DEVELOPMENT APPLICATION

ISSUE D

Project 206-214 Lakemba Street, Lakemba NSW

DRAWN	DATE	ISSUE	AMENDMENT
NB	11.06.2024	A	RESPONSE TO COUNCIL RFI

DRAWING NAME
SECTIONS

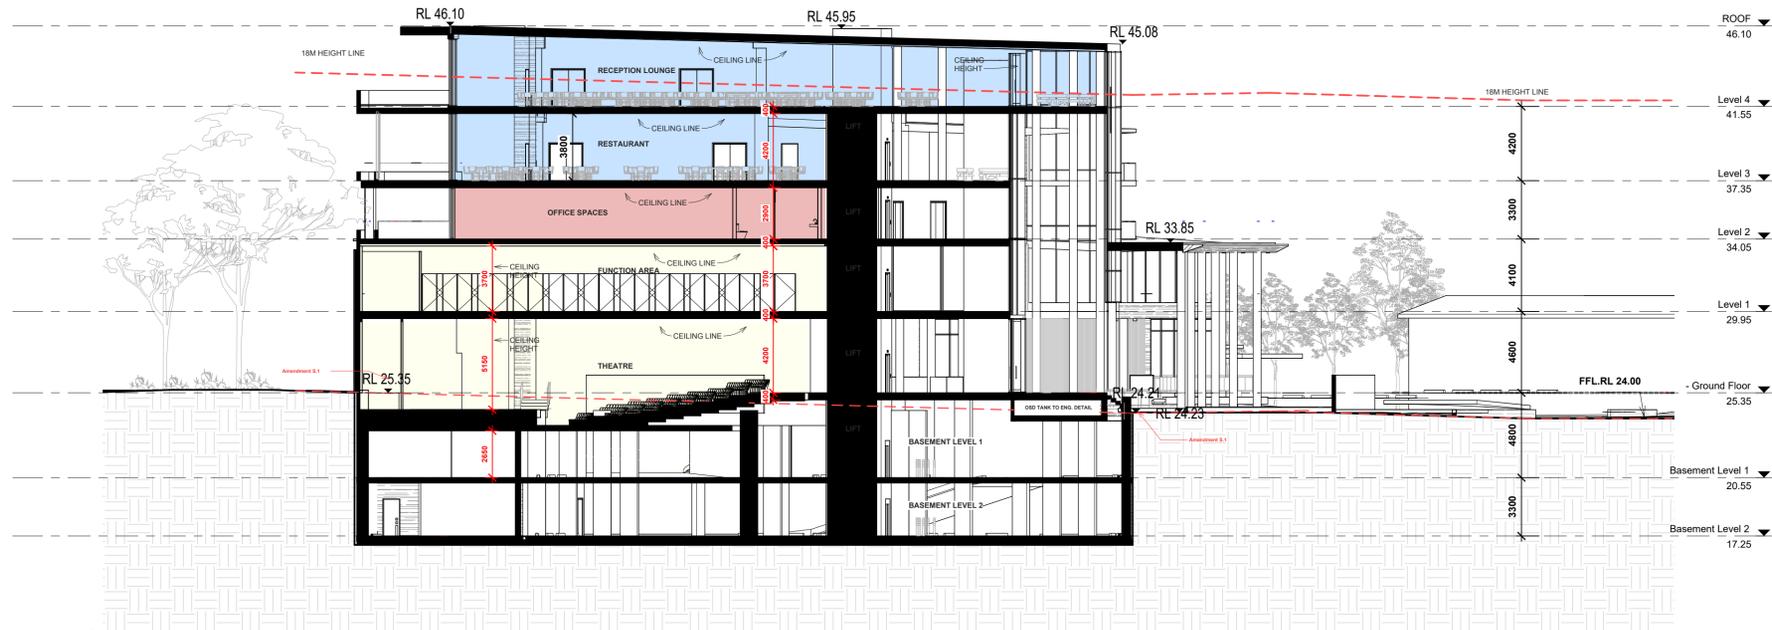
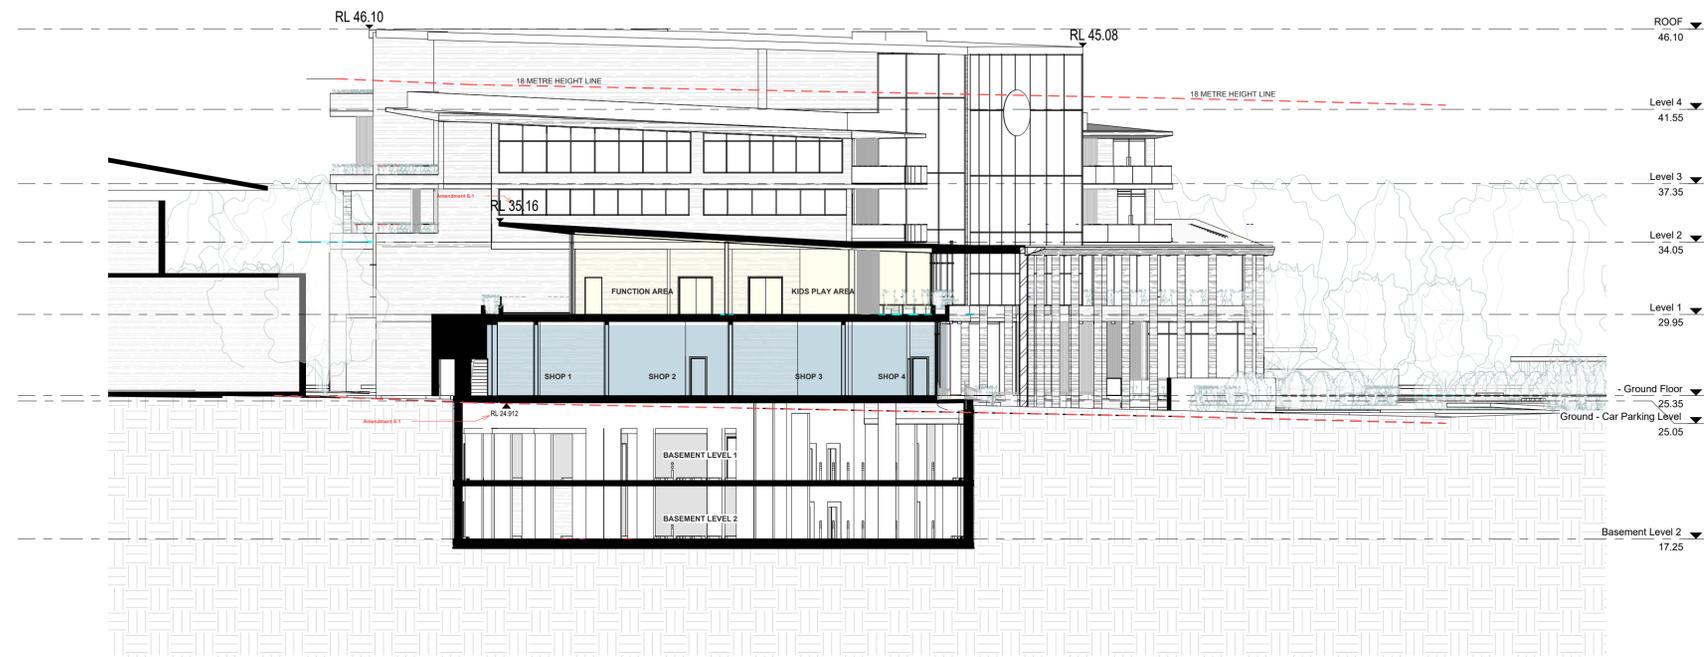
- [Amendment S.1](#) - Natural ground line and rl's directly under highest point of roofs

1 PROPOSED GROUND FLOOR/SITE PLAN
1 : 250

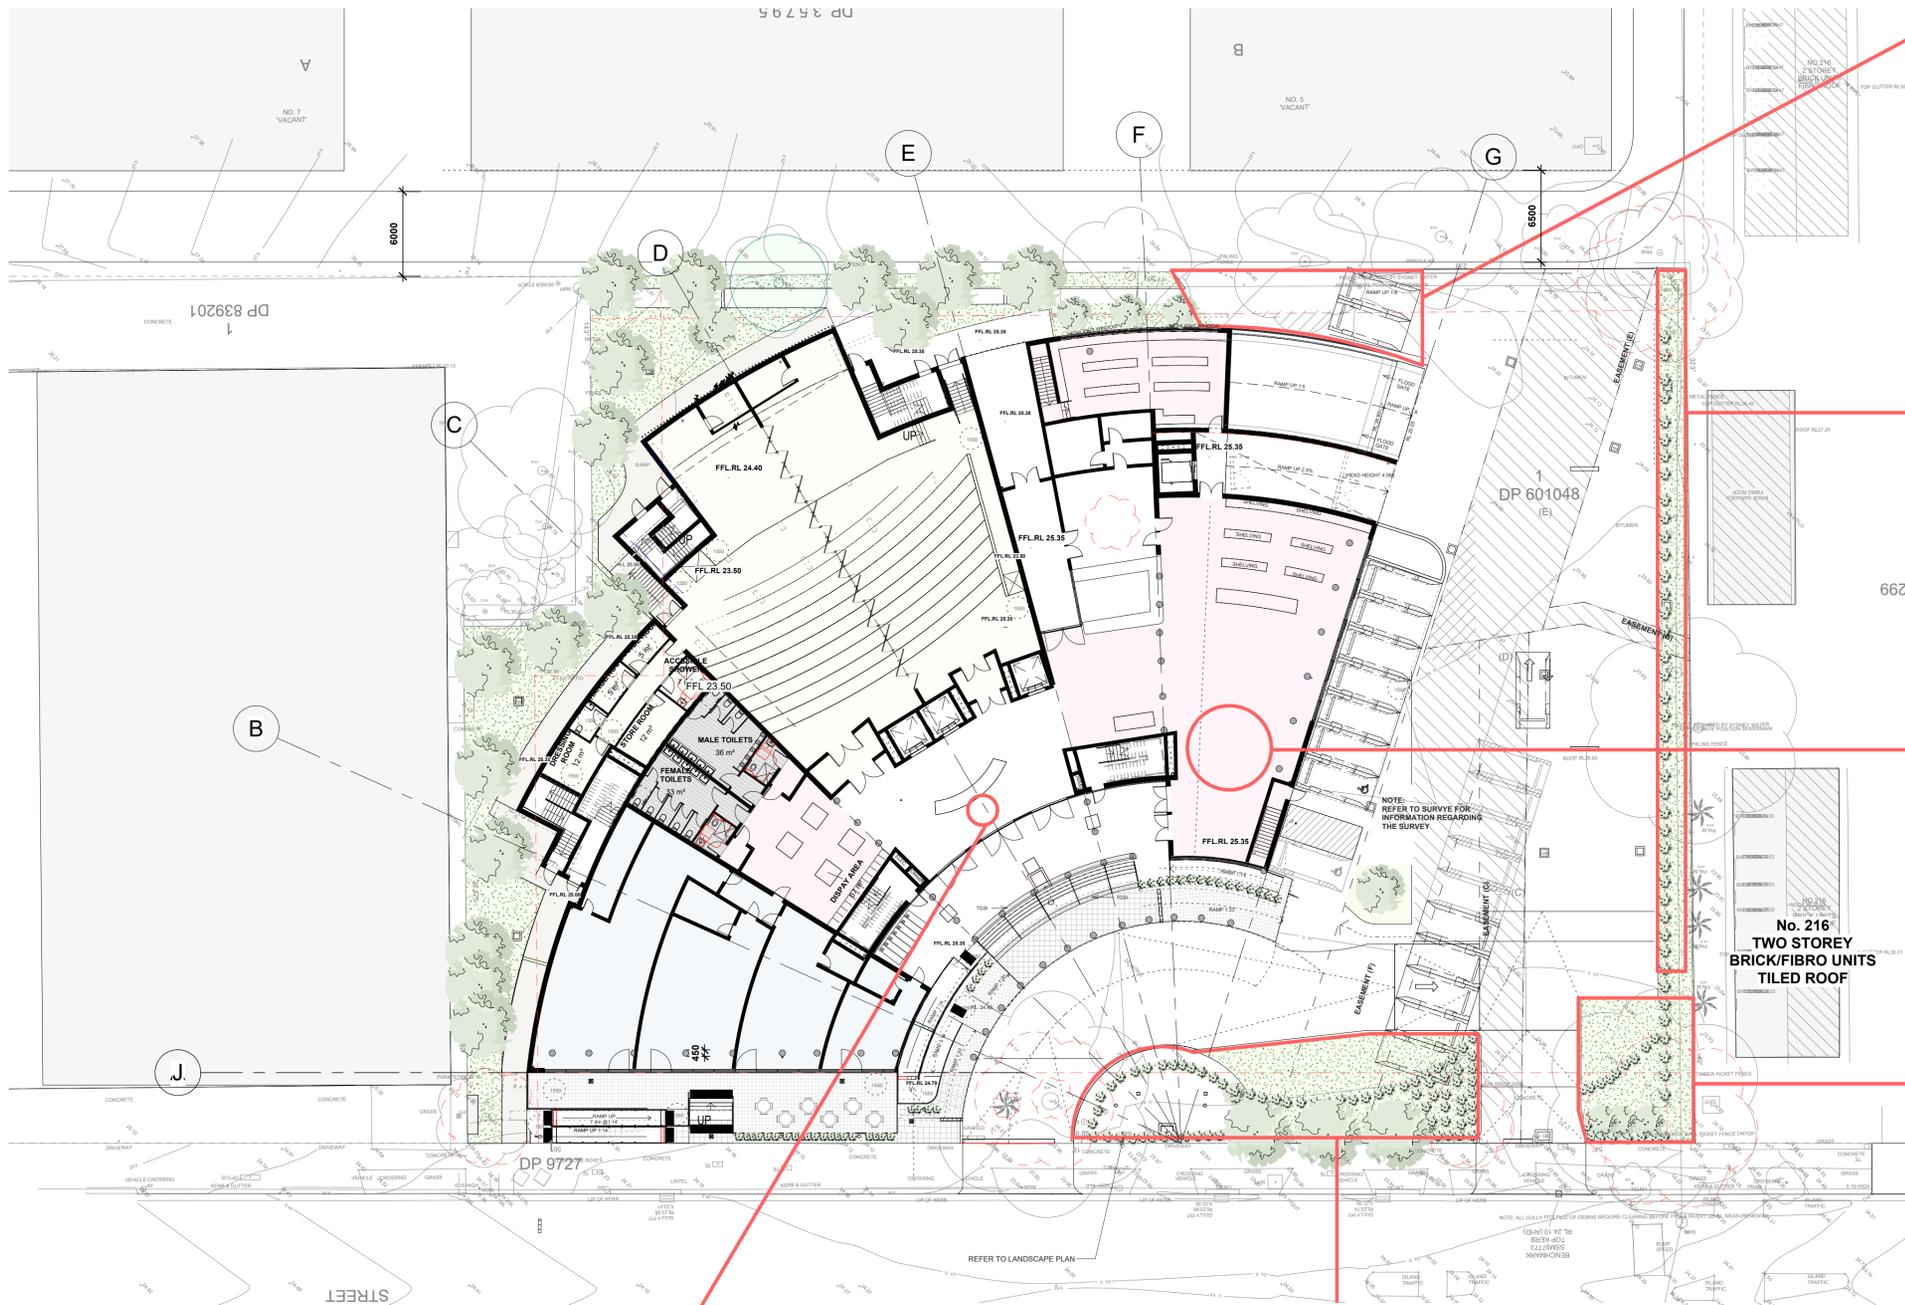
Native Tree Retention
Tree notified as tree 2 is a considerable native eucalypt that exist on the site. amendments to the plan have been made for the retention of the native tree a corner stone of the site. Important to the endemic turpentine / ironbark forest of the area pre urbanization
